Technical Bulletin 30-2010-052

SUBJECT: MANUAL CORRECTION—V-DUTY ADJUSTMENT

MODEL: DXF-51
DXF-51//K2
DXF-51//K3
DXF-51//K4
DXF-51//K5

Figure 1

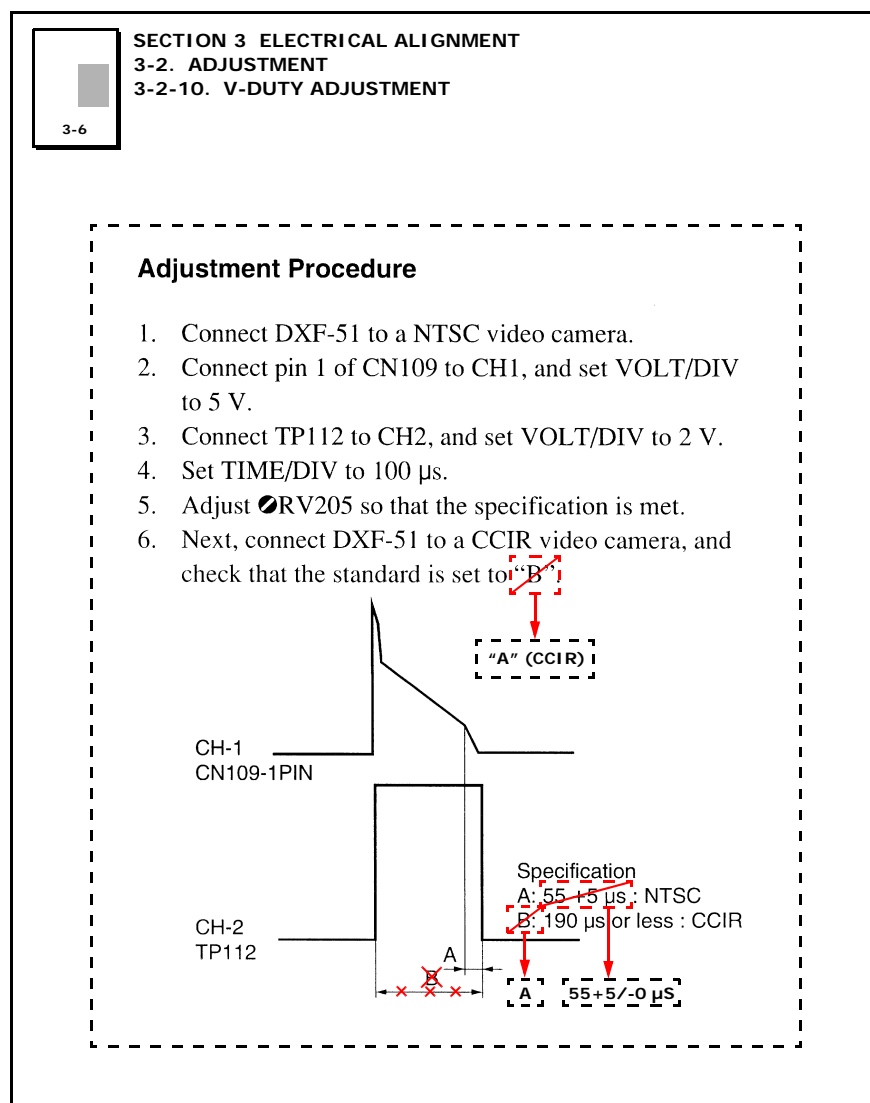
Correct the following manual as shown in Figure 1.
